ADDENDUM NO. 2

PROJECT: Reynolds County Road 364 Bridges

SUBJECT: Project Plans - Barrier Details

ALCORN HOLLOW BRIDGE LAYOUT
& TYPICAL ROAD SECTIONS

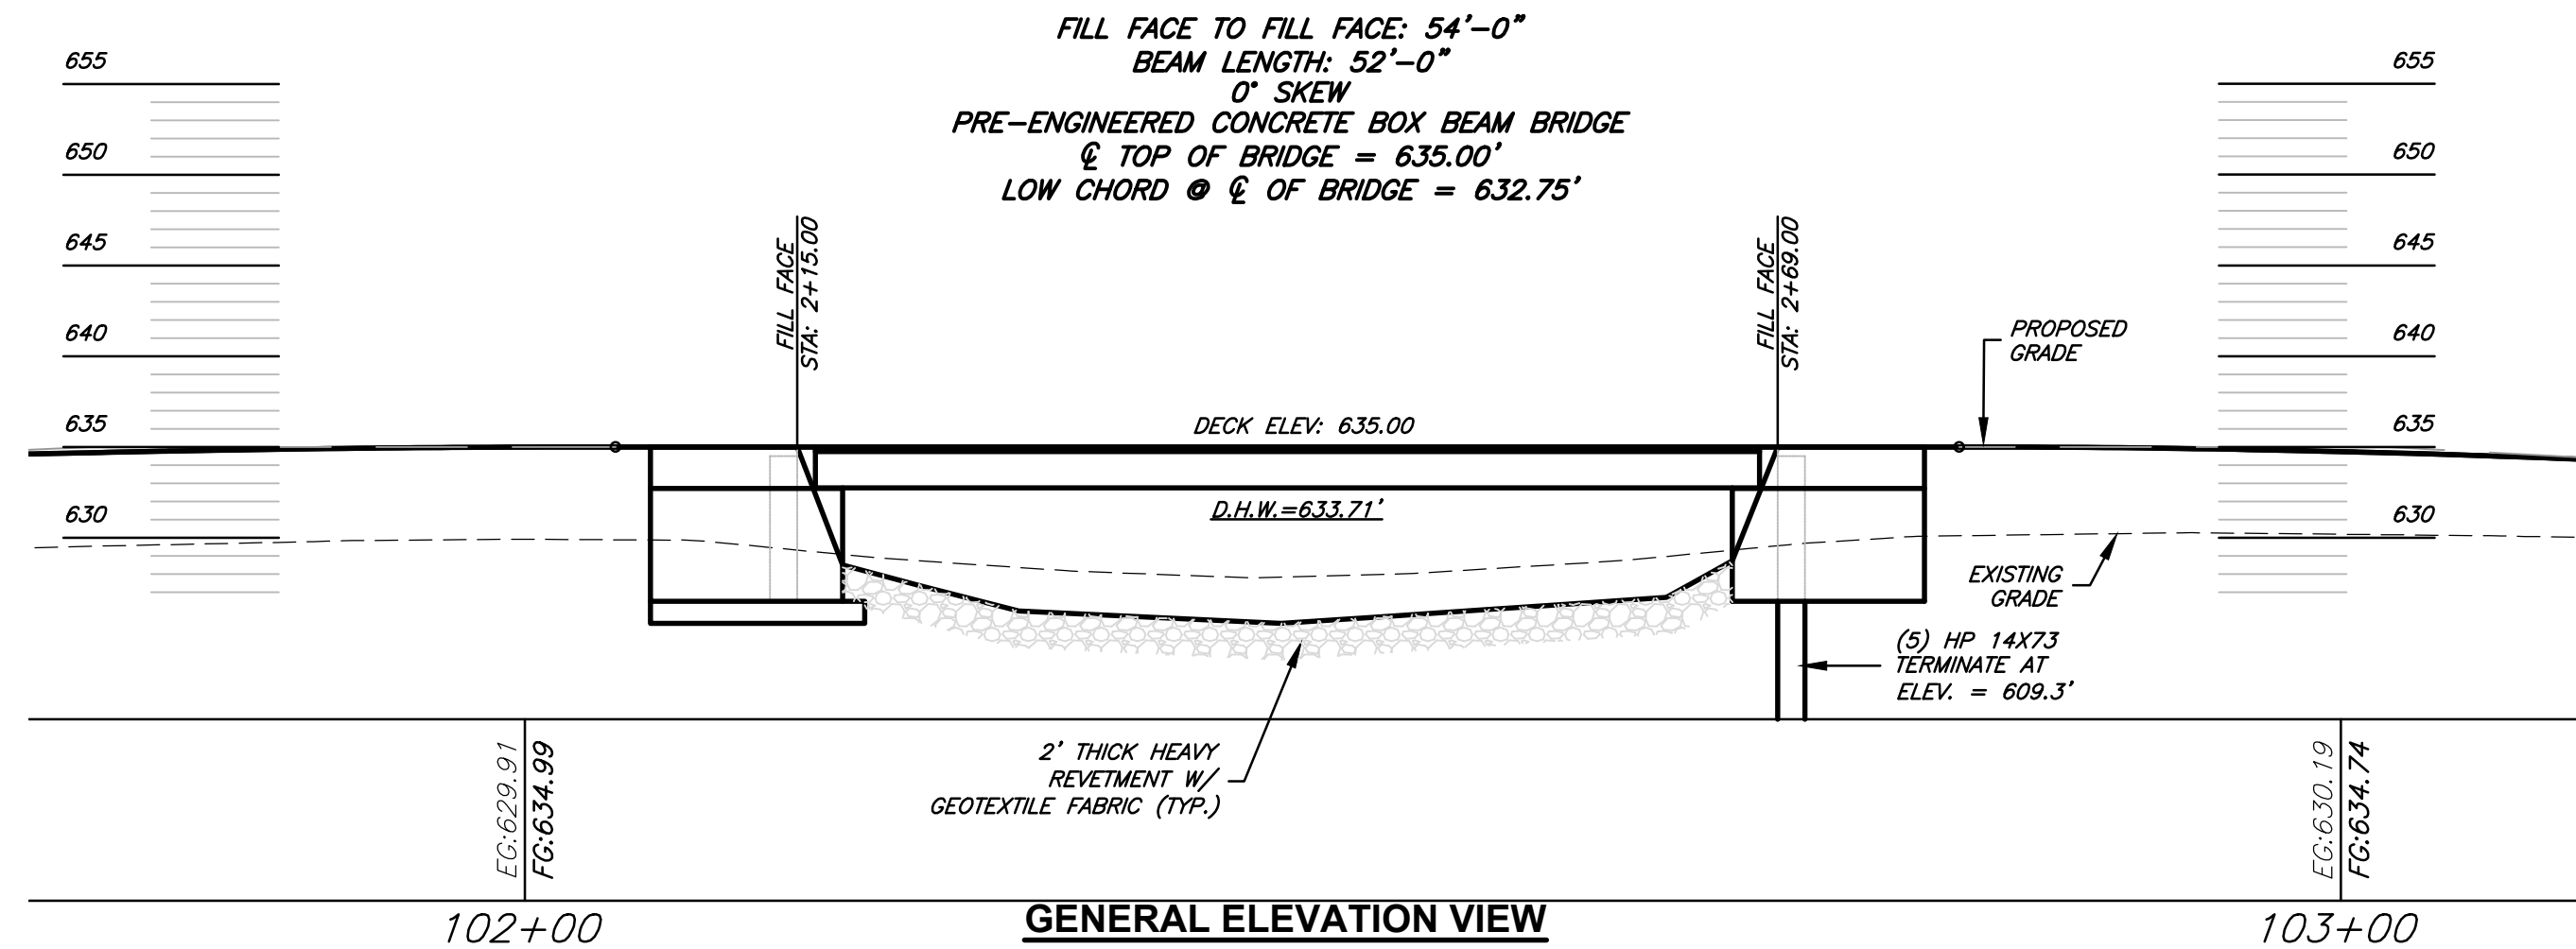
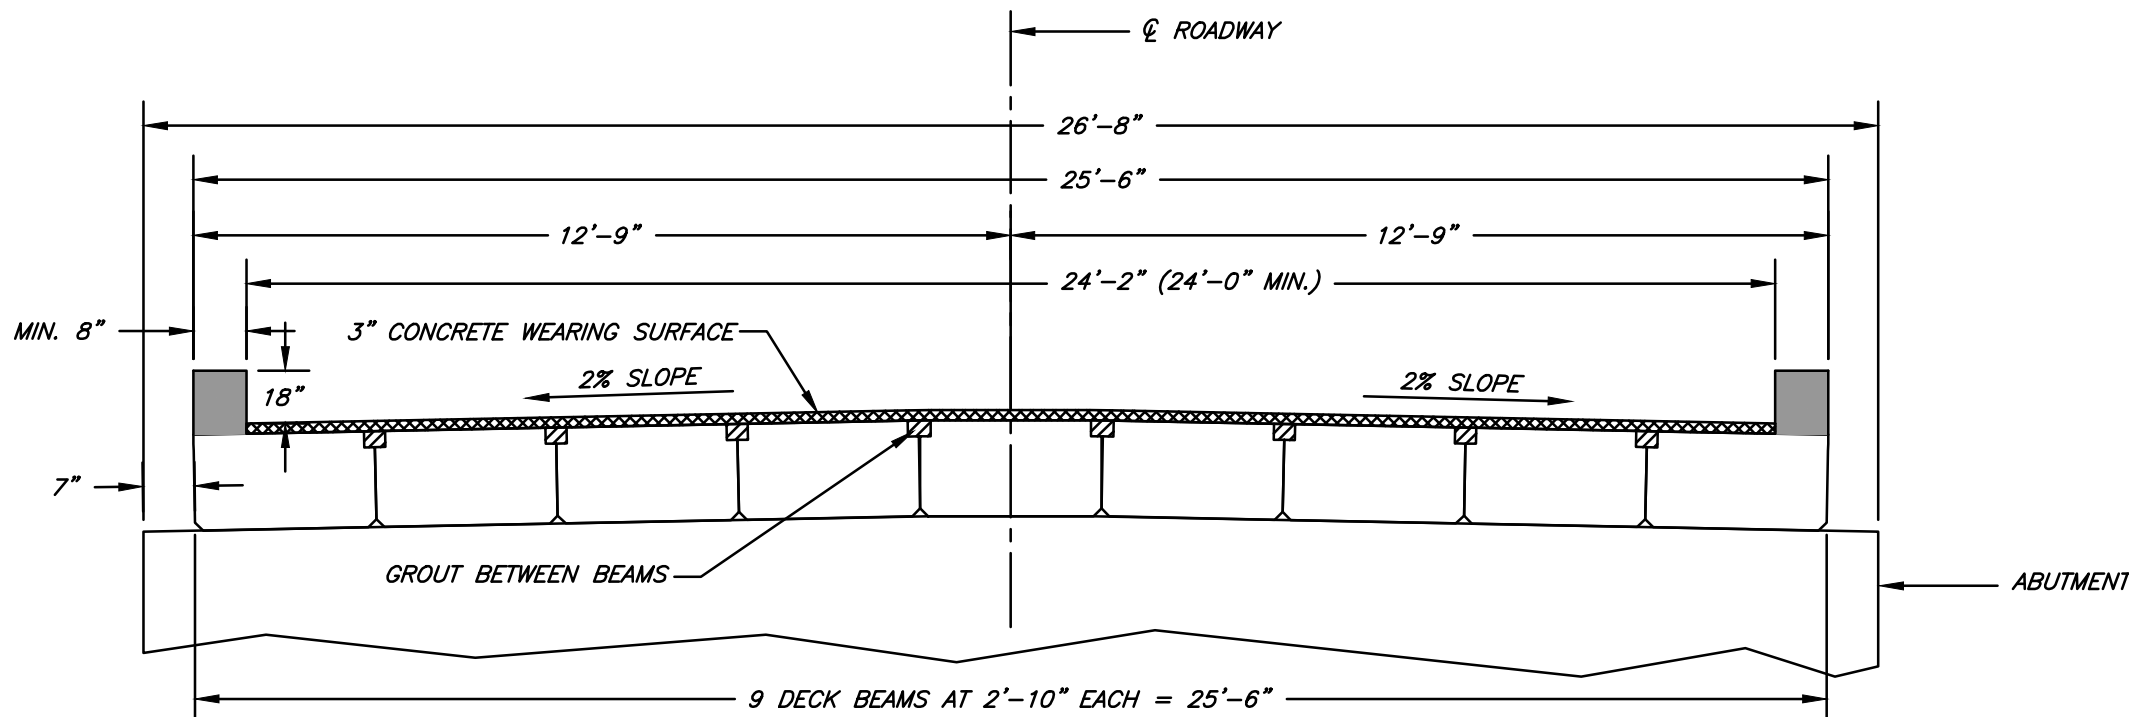
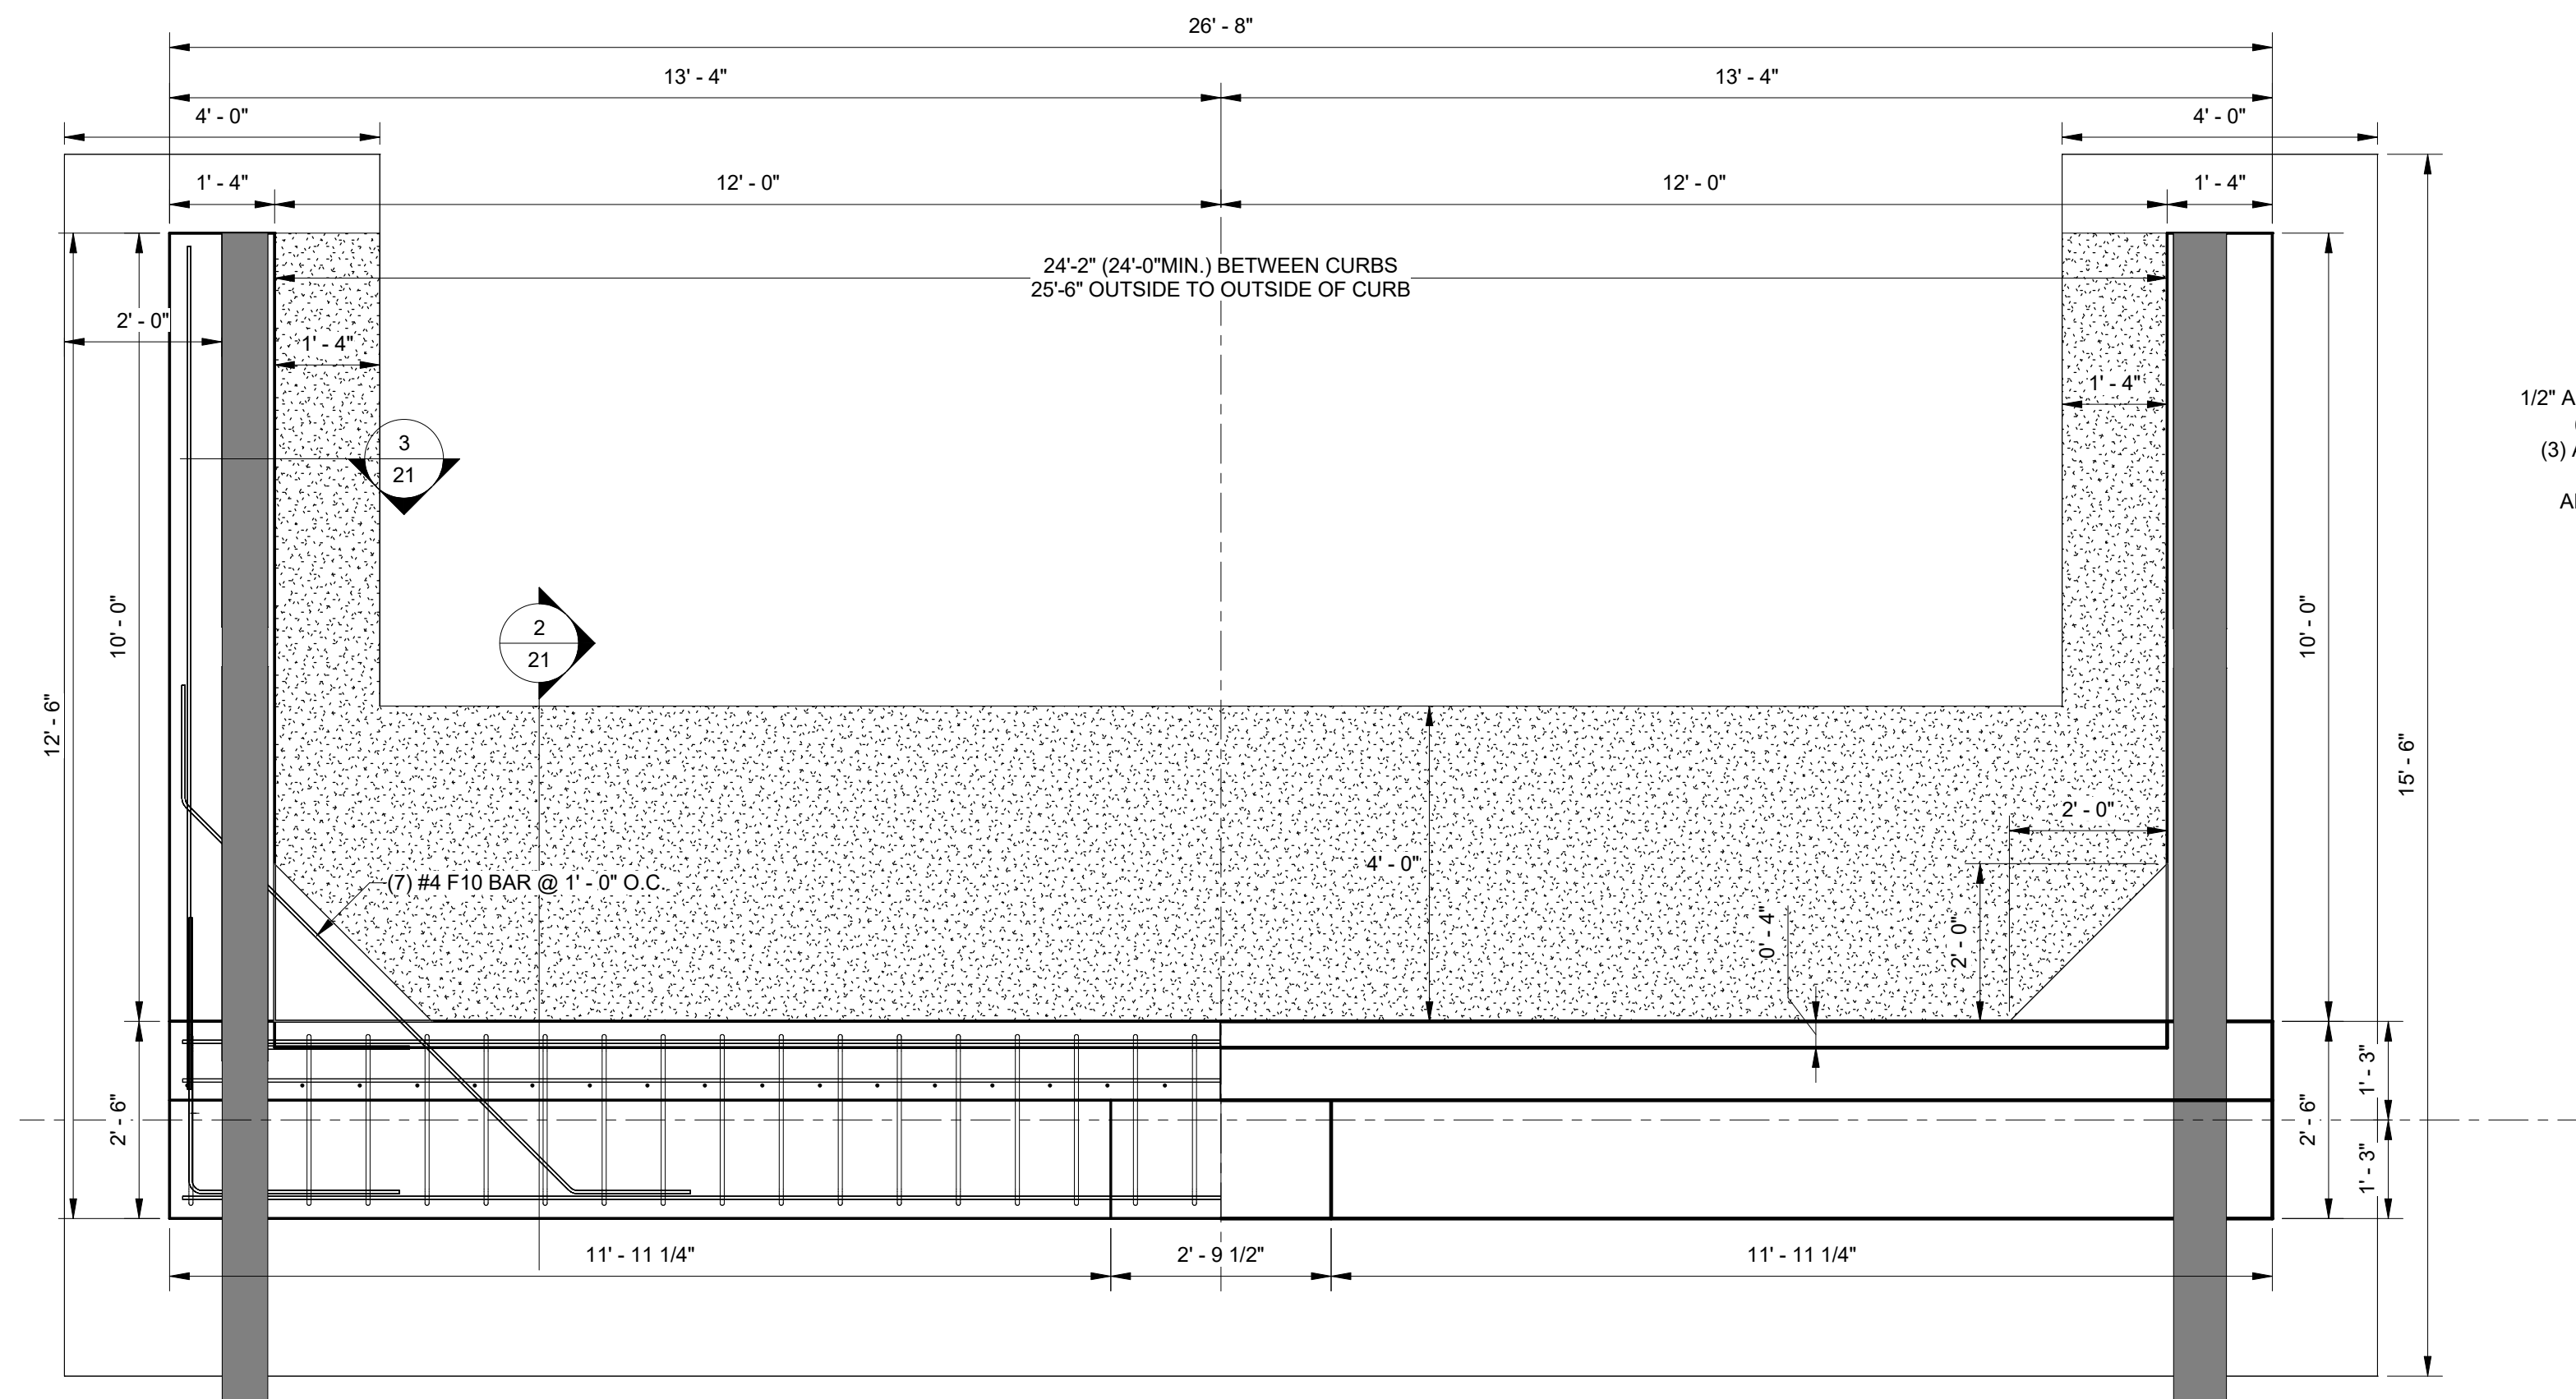
1. Due to a discrepancy, and additional clarification needed for the placement of the barriers, please replace the existing plan sheets **6, 9, 10, 19, 21, 22, and 31** with the attached revised plan sheets.

NO.	REVISIONS	DATE	BY	APP.
1	REVISED BARRIER CURB	12/28/20	JDM	
2	REVISED BARRIER LOCATION	12/28/20	JDM
